MODIFICATION 4 - AMENDMENT REPORT

Gregadoo Solar Farm

Job No: 222222-R01

25 September 2025

Figure 2
Modification 4 As Amended

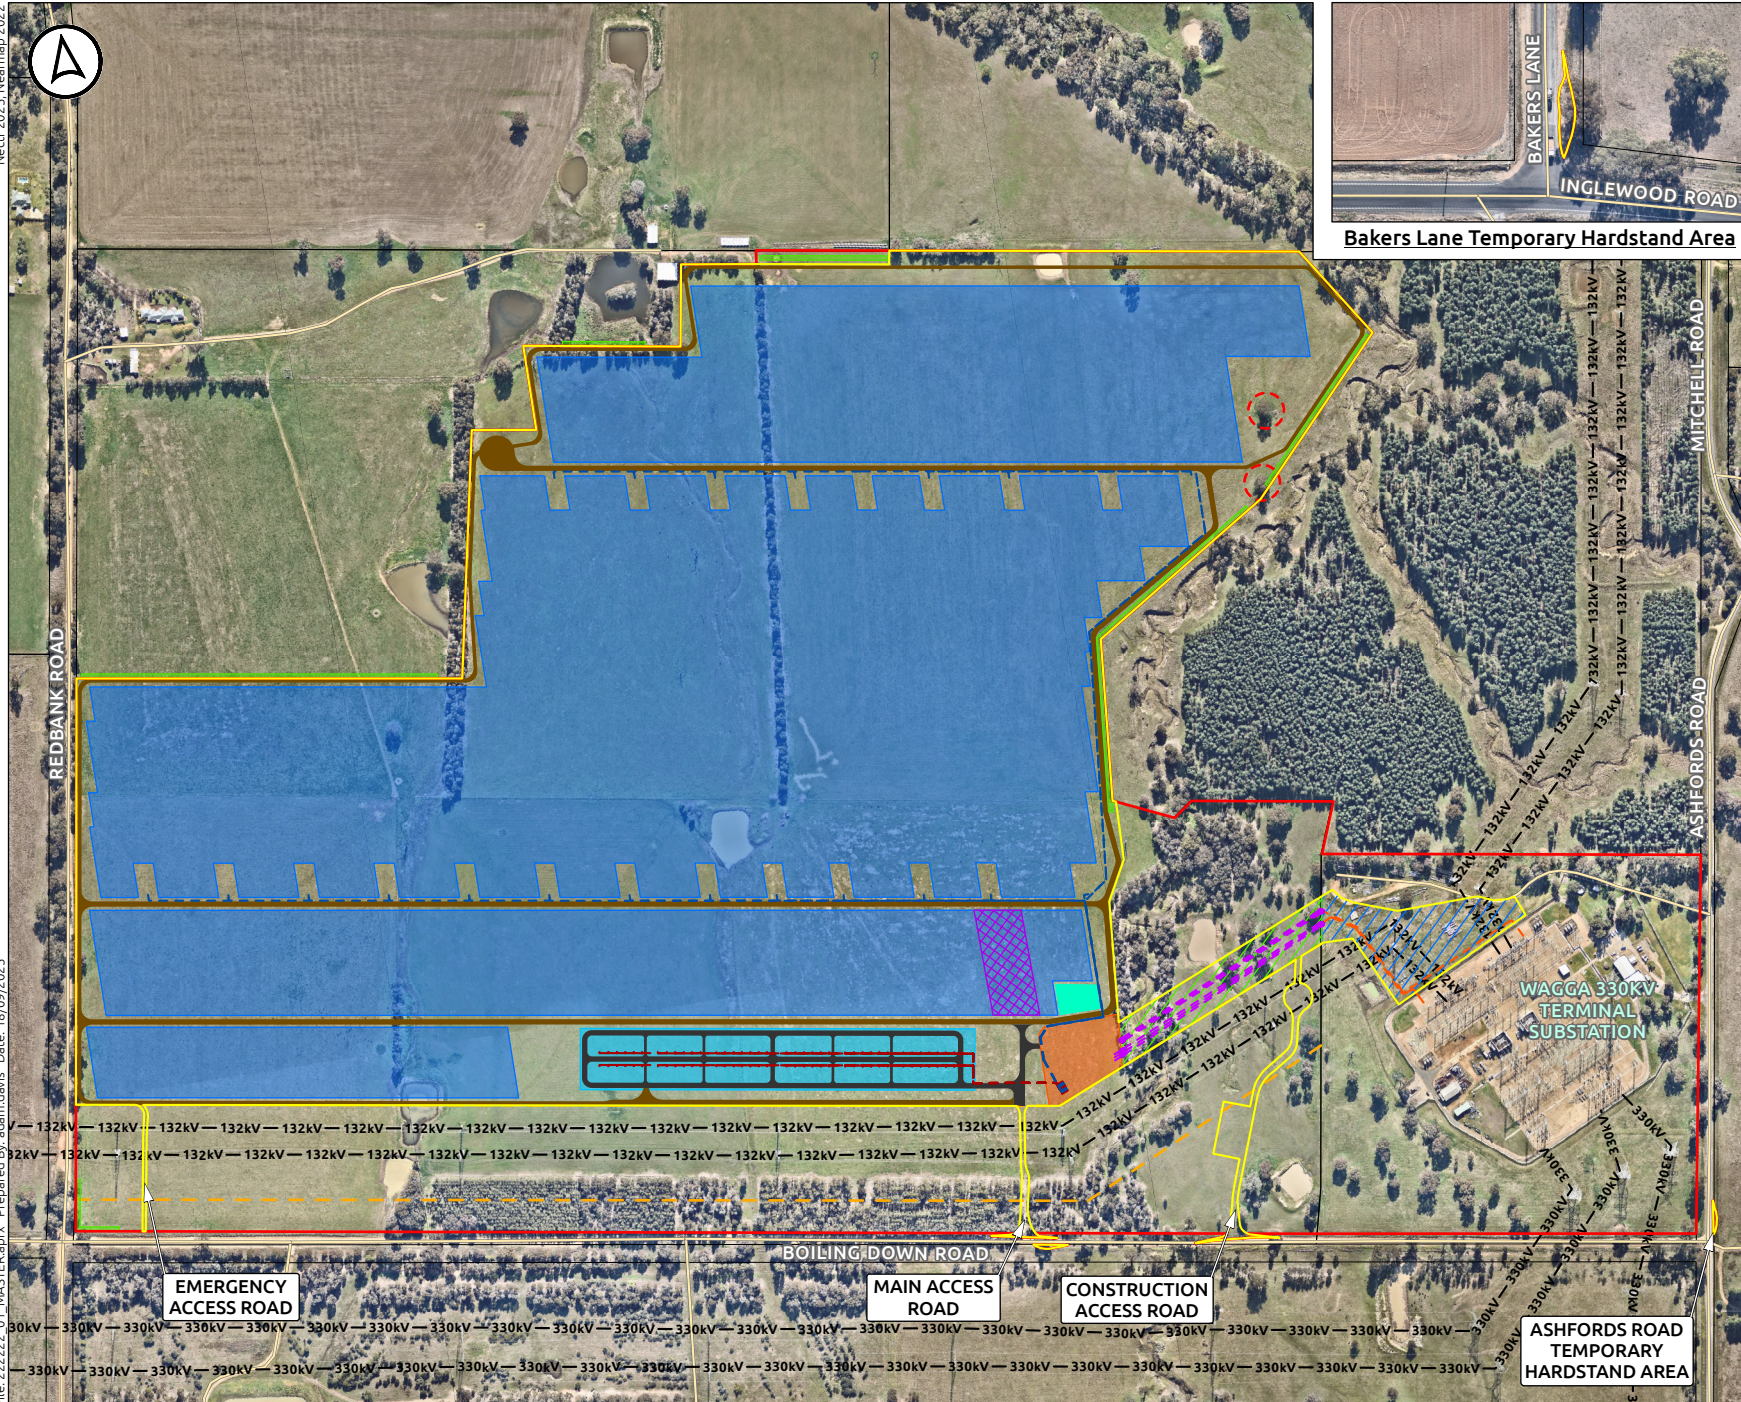
In summary, this amendment does not alter the overall objectives, generation capacity, or external connection arrangements of Modification 4. It solely involves the relocation of the BESS within the approved footprint, with minor associated track adjustments, to optimise site functionality and reduce potential environmental impacts.

Since that time, the design has been further refined to relocate the proposed BESS from the southwest corner to the southeast corner of the development footprint, adjacent to the approved solar farm substation. Minor adjustments to internal access tracks are also proposed to enable efficient construction and maintenance in the new location, while ensuring compliance with environmental protections for Boiling Down Creek and the riparian corridor. The proposed amendment is illustrated **Figure 2**.

**Figure 6
Modification 4 Site Plan**

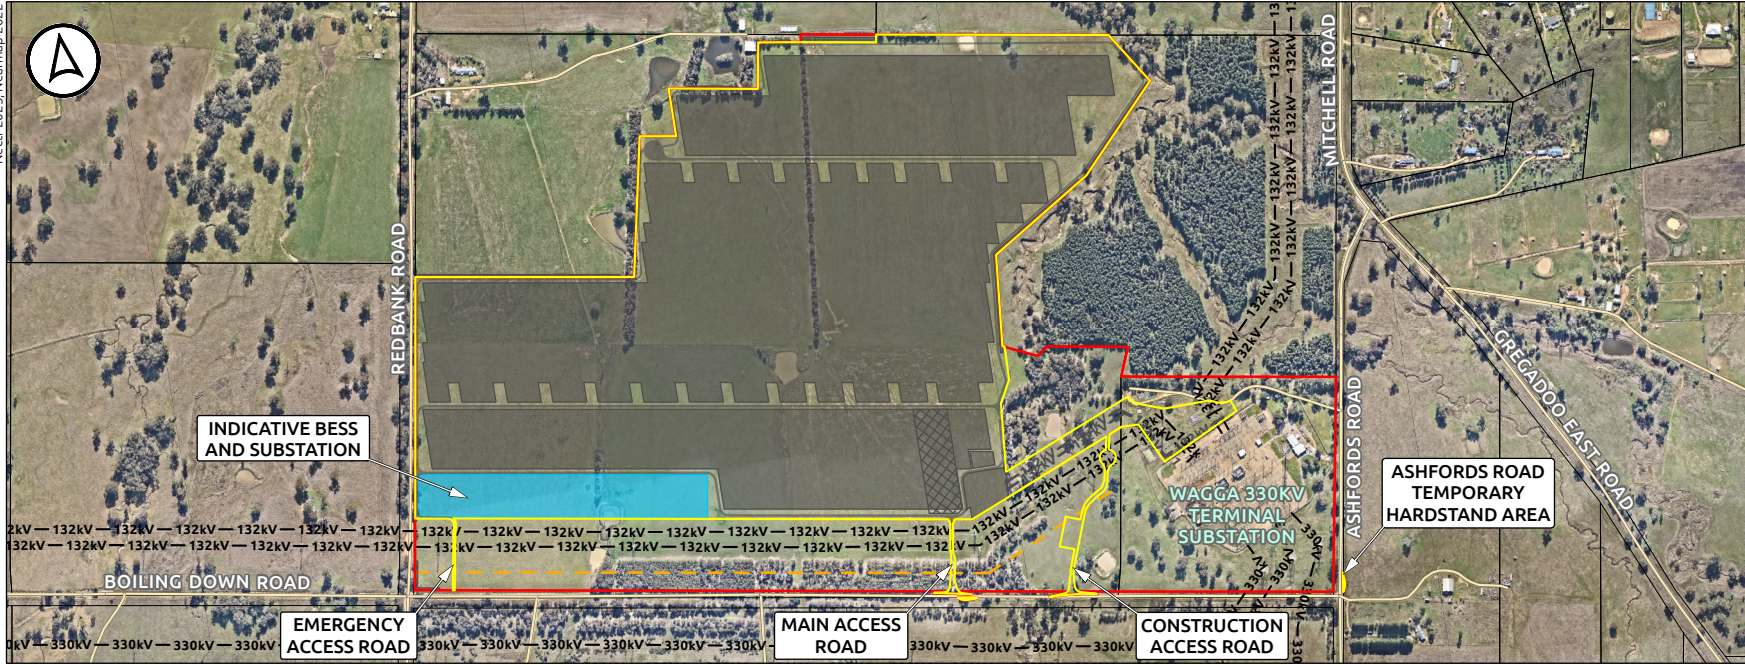
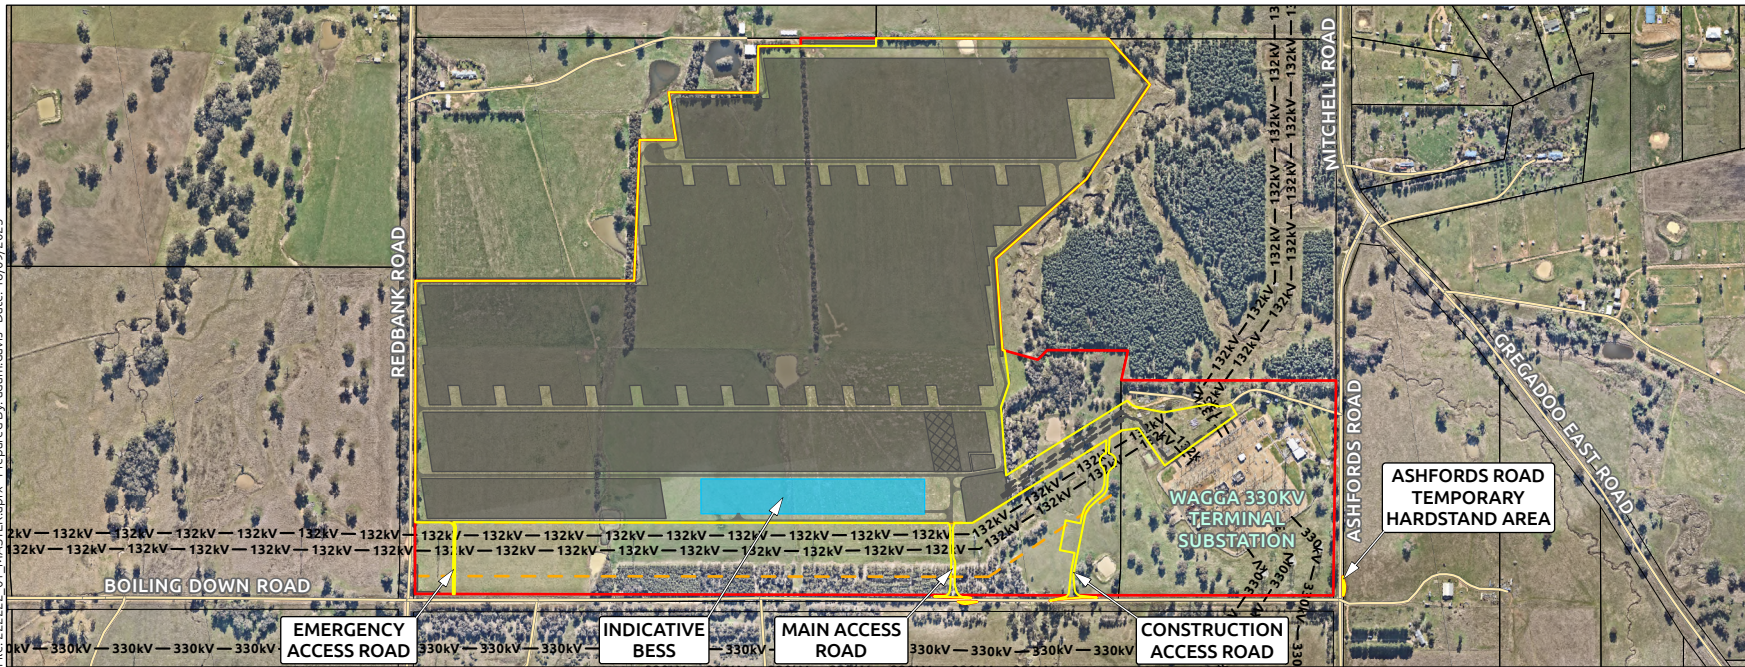
In summary, Modification 4 as amended involves the addition and relocation of a 200 MWAC / 400 MWh BESS within the approved development footprint, the provision of a new site access point and internal access track, and refinements to substation arrangements.
